## 工程指示 / 要求簡箋(E.I.)

工程指示編號：EI / 9055 / 25 修改版次：

工程名稱：將軍澳日出康城

工程項目：幕牆 第 7 次 補玻璃 16 件 (小業主單)

樓層: 9-67 28 BF 單位: F

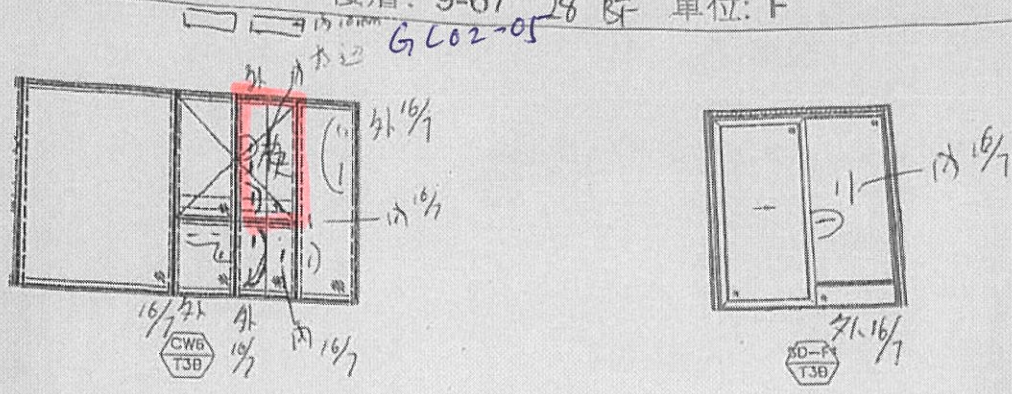
16-7-2015 張 Kelvin

樓層: 9-67 35AA 單位: A

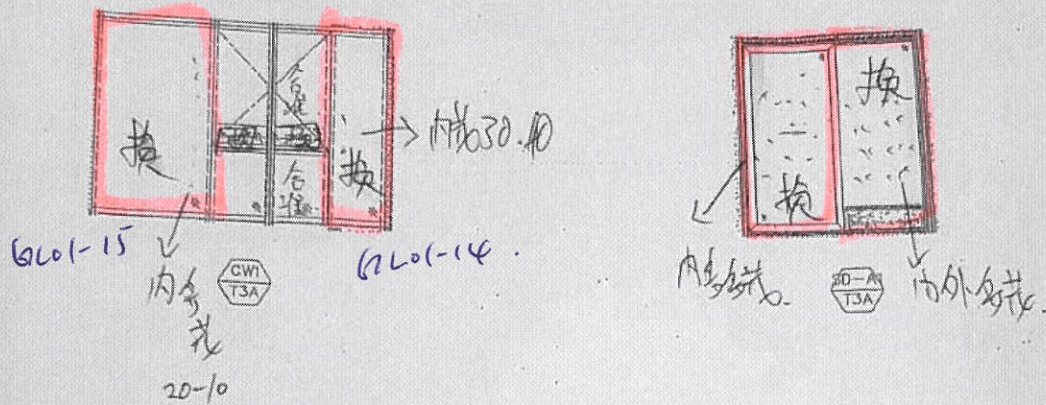
17-6-2025 2層 OK KOLZ

趨門外花.

拆色OK. ✓

房1房2 护框要換.

樓層: 9-67 43BF 單位: F

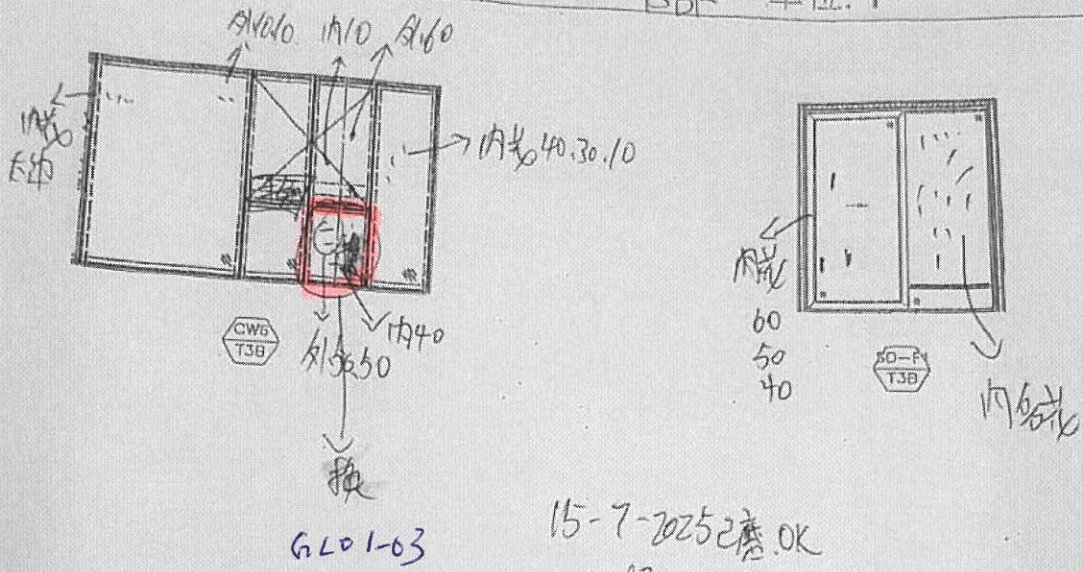
抽換如。

主房并栏深表換。

13  
PART ELEVATION  
FOR CURTAIN WALL

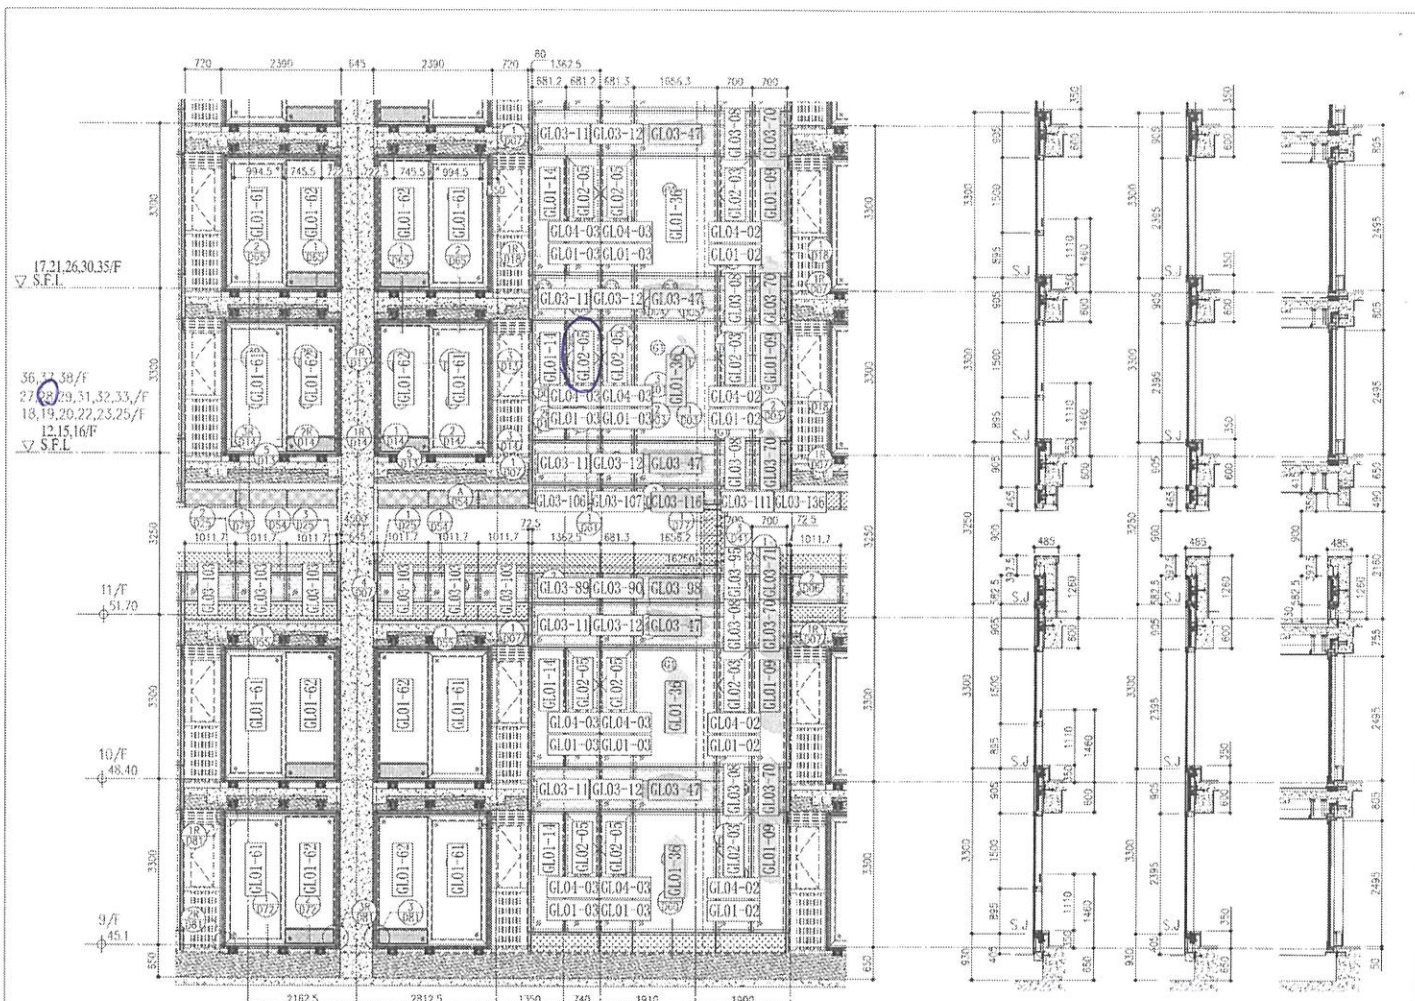
GL02-05  
28BF

1 PART ELEVATION FOR CURTAIN WALL

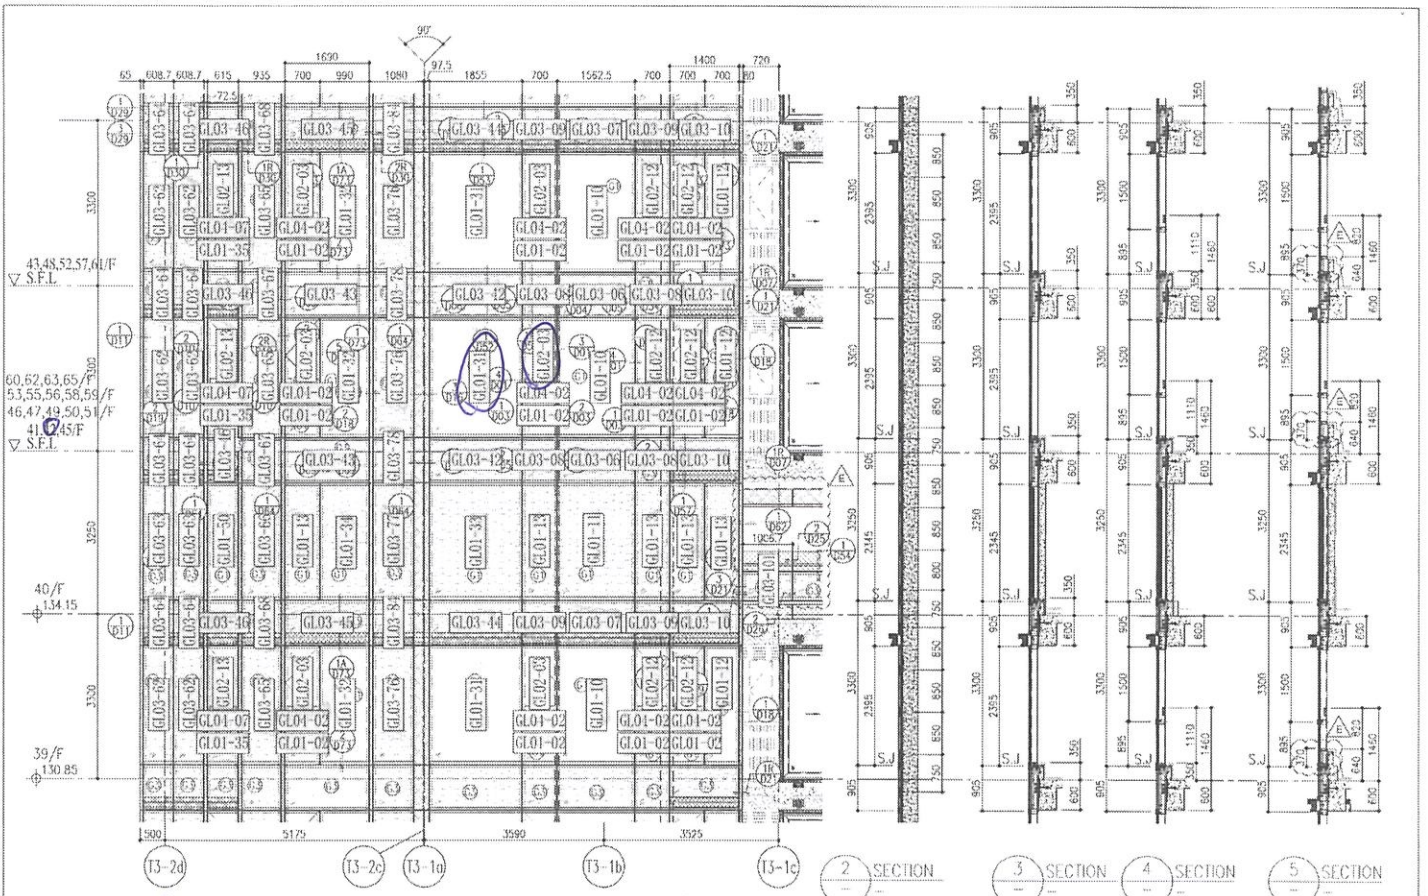
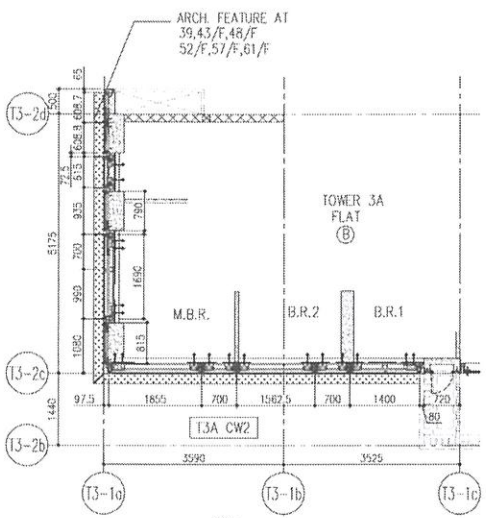
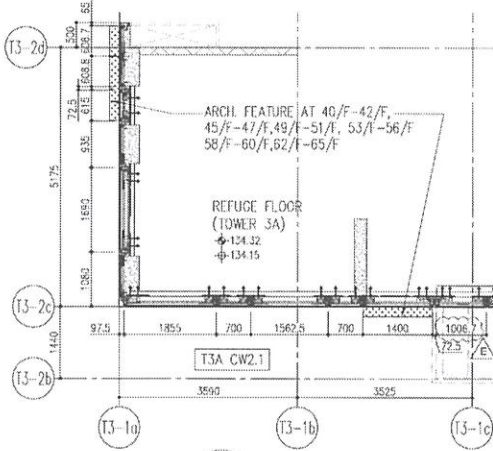
GLO1-31  
42AB

GLO2-03  
42AB

1 PART ELEVATION FOR CURTAIN WALL

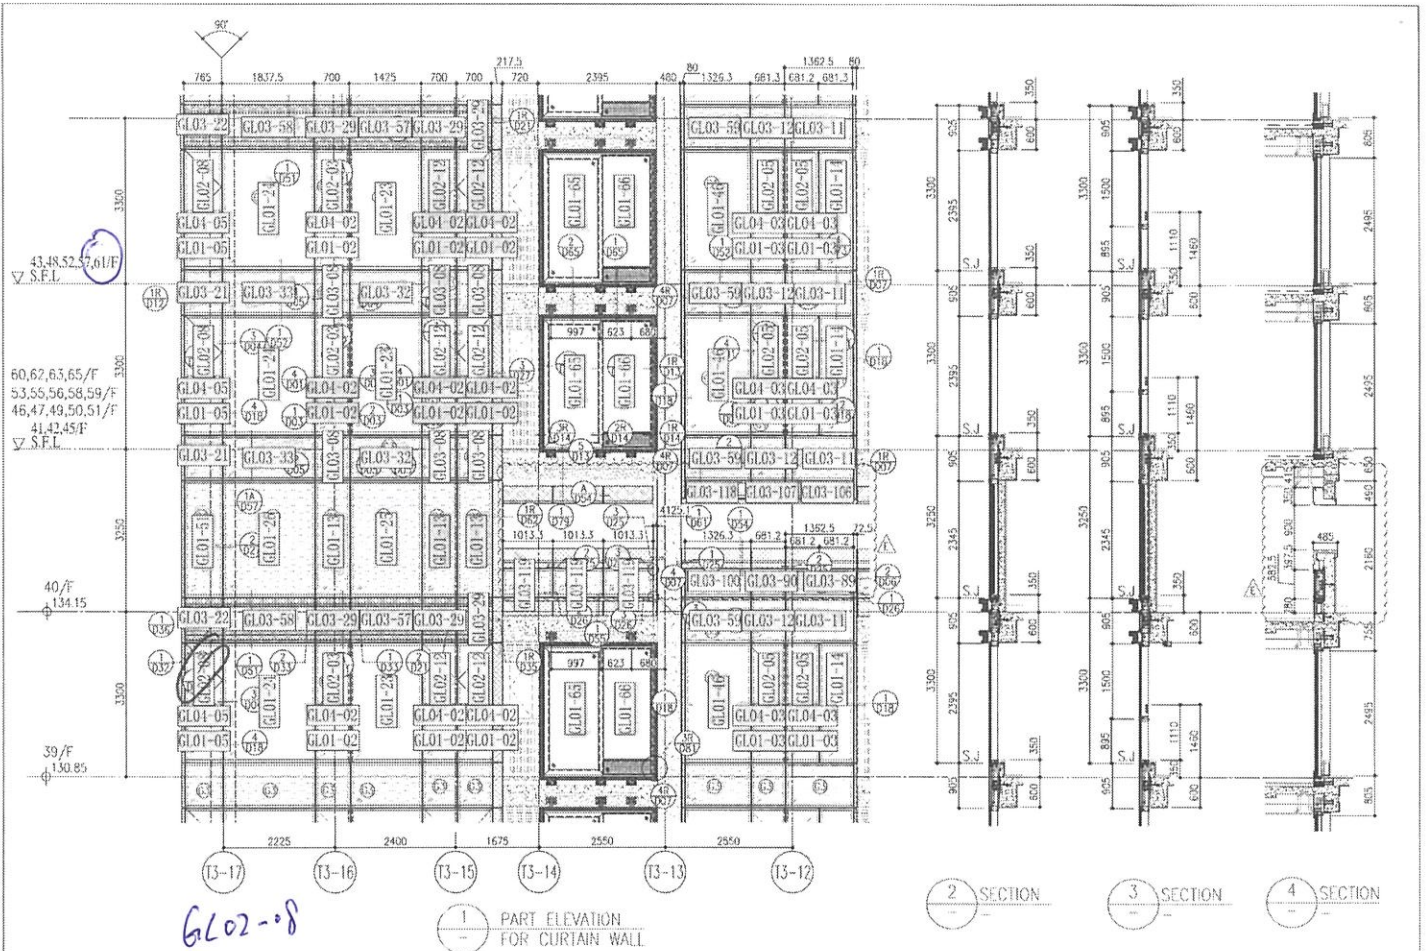
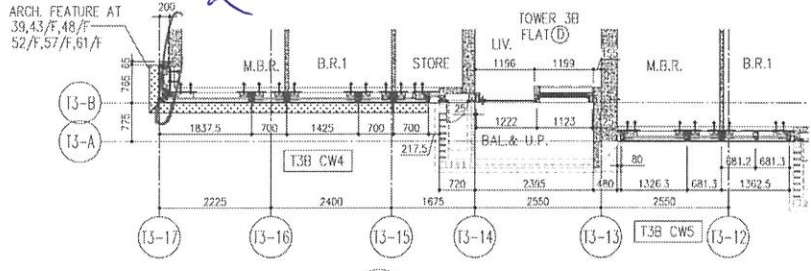
G1.02-08  
61BD  
裂
